*Ross ISR Project USNRC License Application
Crook County, Wyoming*

**RAI Question and Answer Responses
Environmental Report
Docket #40-09091**

Prepared by:
Strata Energy Inc.
1900 W. Warlow Drive, Bldg A
PO Box 2318
Gillette, WY 82717-2318

MARCH 2012

Figure ER RAI GEN-1-1. Ross ISR Project Current Baseline Plan View.

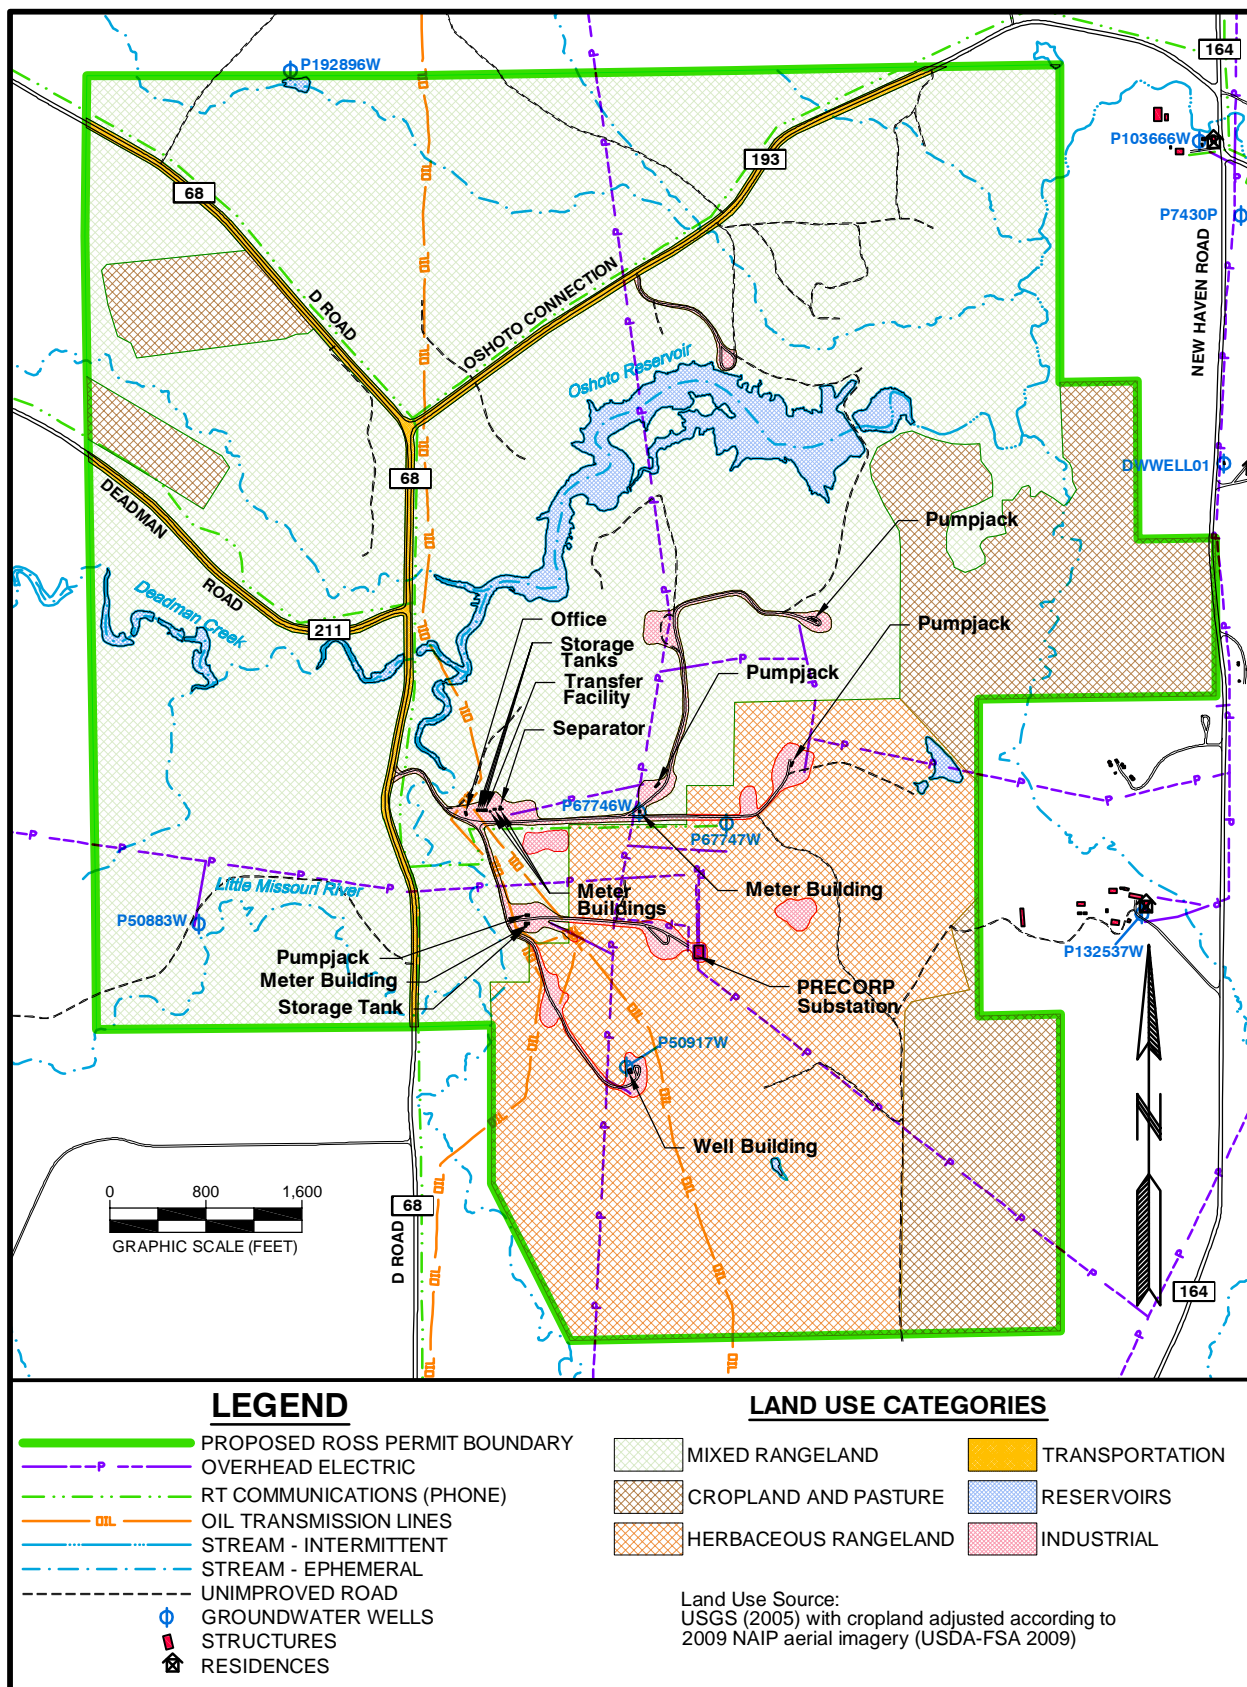
- A. *Please provide a current, baseline plan view of the existing Ross Project site, showing each of the physical (man-made) attributes listed below.*

These plan view figures should present a more regional view than Figure 1.2-5 and greater detail than present on Figures 1.2-6 and 1.2-7 in the Environmental Report (ER). In addition, these figures should be uncluttered with information not specifically requested (e.g., the mineralization areas). However, inclusion of some naturally occurring site features, such as the Oshoto Reservoir and the other water bodies such as the Little Missouri River and Deadman Creek, would enhance the clarity of the figures, as would the elimination of topographic contours in these particular views. These figures should be in an electronic format. The view of the existing, current site will serve as a baseline view and the other phased views will assist in the NRC's evaluation of Proposed Action's impacts progressively over time as required by 10 CFR Part 51.

Figure ER RAI GEN-1-1 depicts the current baseline plan view of the proposed Ross ISR Project area including land use, water bodies, streams, existing disturbance, nearby residences and infrastructure. As requested, this figure presents a more regional view of the proposed project area, including the entire proposed NRC license area, than ER Figure 1.2-5, which depicts only the CPP area.

Figure ER RAI GEN-1-2. Anticipated Facilities at the End of Construction.

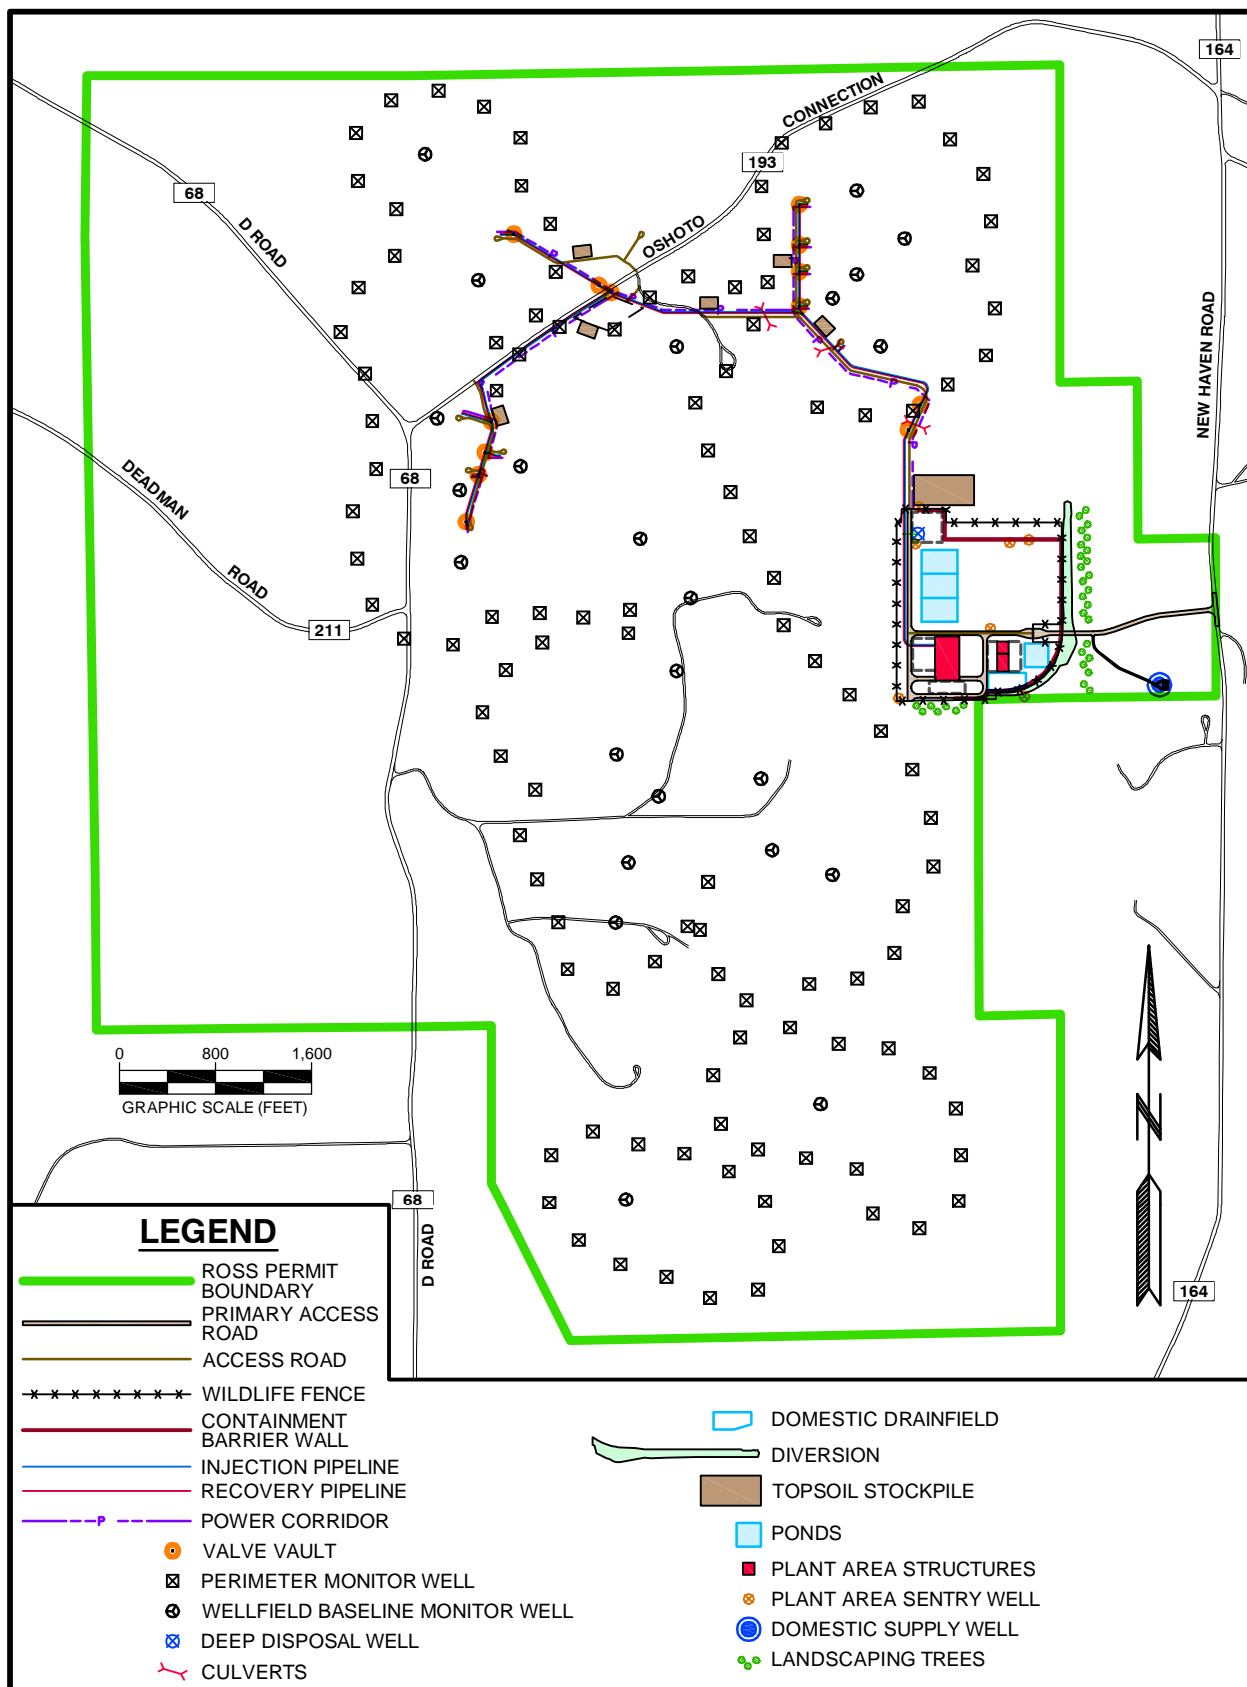
- B. Please provide a plan view of the Ross Project site using the same scale and size as the baseline plan view and showing each of the physical (man-made) attributes listed below for each phase (i.e., construction, operation, aquifer restoration, and decommissioning) of the proposed Ross Project.*

Figure ER RAI GEN-1-2 depicts the anticipated facilities at the end of facility construction. This time period is indicated in ER Figure 1.3-1 as the beginning of year 1 after regulatory approval. The facilities anticipated to be constructed include the primary access road, CPP area diversion, containment barrier wall, deep disposal well proximal to the CPP, domestic well and access road, lined retention pond 1, sediment pond, wildlife-proof fencing around the controlled area boundary, CPP, administration building and warehouse/maintenance building, and domestic drainfield. In addition, it is anticipated that the wellfield access roads, pipelines, valve vaults and power to the first mine unit will have been completed along with all of the perimeter and wellfield baseline monitor wells for both of the mine units. (Refer to ER Section 1.2.5 for a description of mine units; the wellfield modules will be divided into two mine units within the project area.) Construction and installation are also anticipated to have been completed on the module buildings in the first mine unit along with some of the production patterns; however, wellfield modules are not shown on this figure since most wellfield construction will occur after the end of facility construction.

Figure ER RAI CI-1-1. Potential Future Lance District Projects

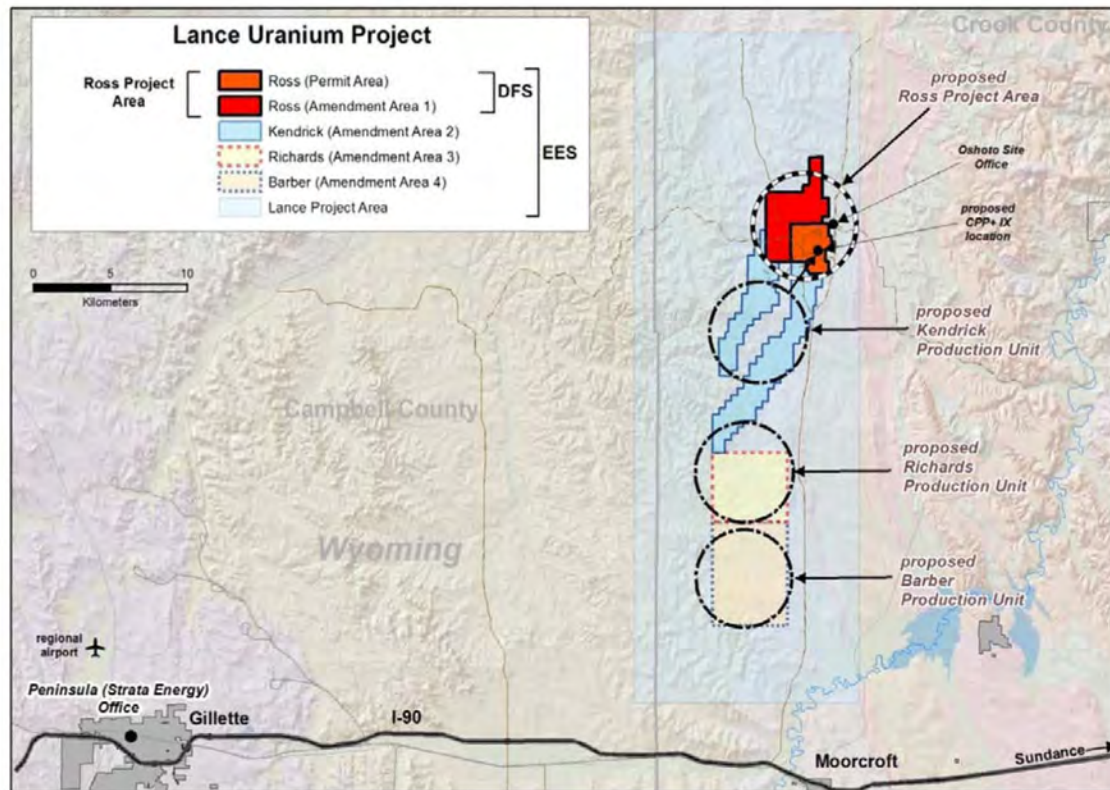
- A. *Please provide the proposed locations of the other projects relative to the Ross Project site.*

Figure ER RAI CI-1-1 depicts potential future Strata projects (license amendment areas) within the Lance District. As described in ER Section 2.2.7.1, Strata has identified significant uranium resources within the Lance District. The currently identified potential license amendment areas include an area adjacent to the proposed Ross project area (Ross Amendment Area 1), and the Kendrick, Richards, and Barber satellite facilities south of the proposed Ross project area (Peninsula 2011). Strata continues exploration drilling outside of the proposed Ross project area within the Lance District. As this exploration drilling continues, the number, location, and size of potential projects will likely change. Refer to the response ER RAI CI-1(B) for a discussion of the potential schedule of future Lance District satellite projects and to the response to ER RAI CI-2(B) for a discussion of potential cumulative impacts from these projects.

Figure ER RAI CI-1-2. Potential Lance District Development Schedule

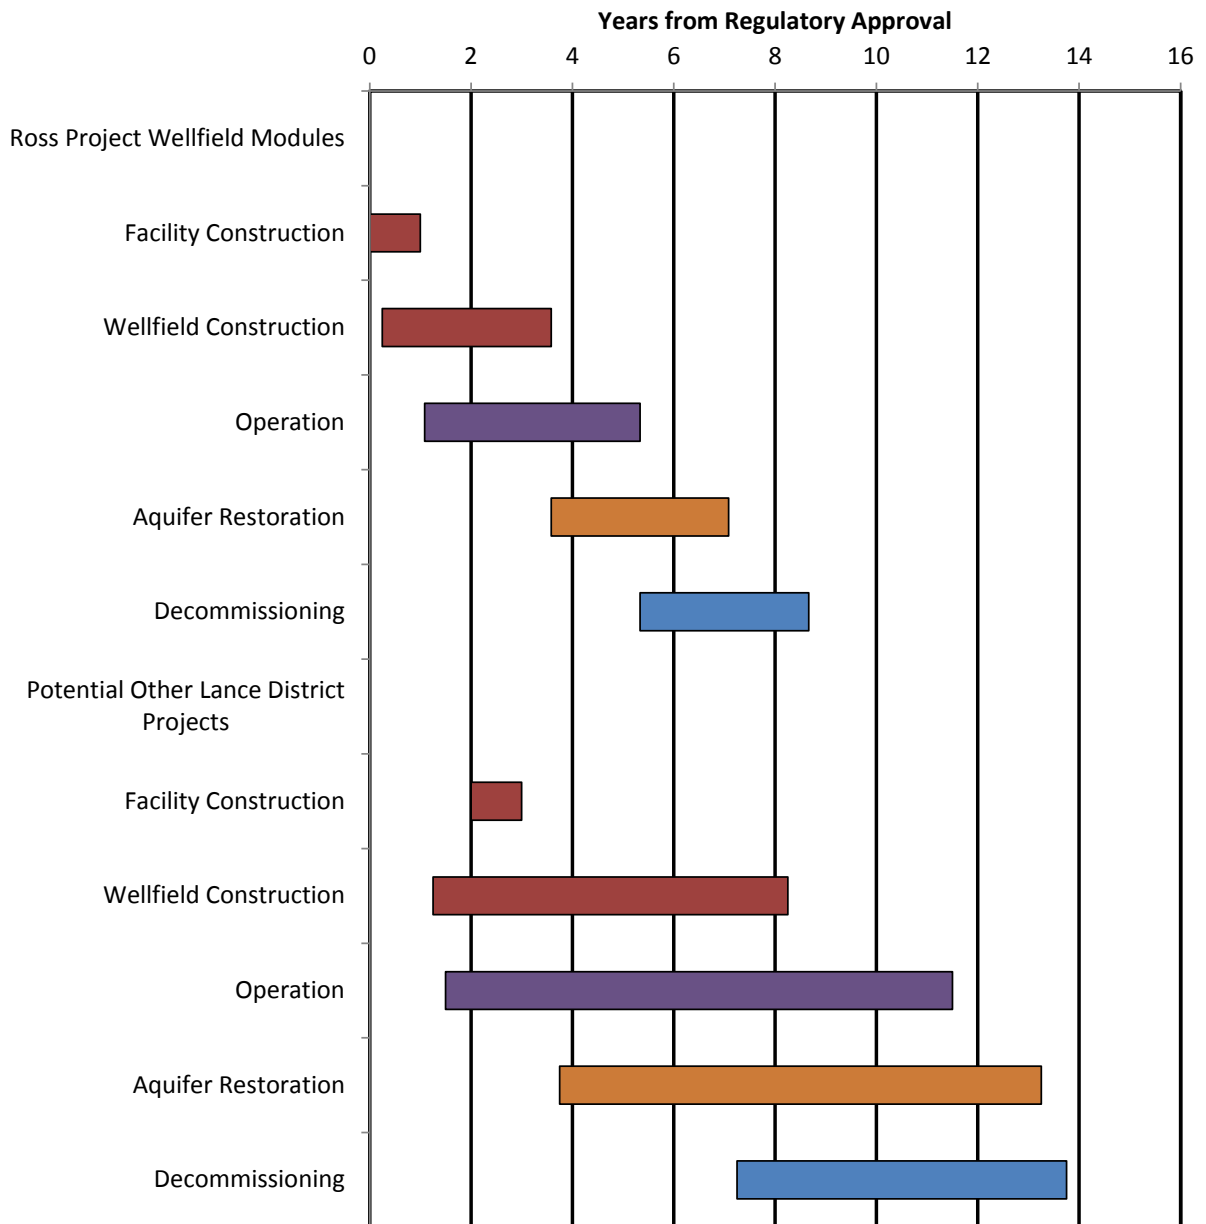
B. Please provide a schedule relative to the Proposed Action for these other projects and their activities.

Figure ER RAI CI-1-2 depicts the potential Lance District development schedule. This figure compares the potential schedule with the proposed Ross schedule as requested in the RAI. Reasonably foreseeable plans include steady-state operation of three satellite facilities. Based on potential resources in the Lance District, Strata anticipates that the total duration of ISR uranium production could be 11 to 18 years, including the Proposed Action. The potential Lance District development schedule assumes that wellfield construction in the first amendment area would begin 12 months after initial construction. The total duration of wellfield construction is estimated to be approximately 7 years. Facility construction, which would be primarily associated with the Barber Satellite Facility remote IX plant and associated ponds, is estimated to last 9 to 12 months. Operation of the amendment area wellfields is anticipated to last 10 to 17 years. Aquifer restoration is anticipated to begin approximately 2 to 2.5 years after the start of operation and last approximately 9 to 16 years. As with the Proposed Action, significant overlap is anticipated between operations and aquifer restoration, since aquifer restoration of individual wellfield modules would begin almost immediately
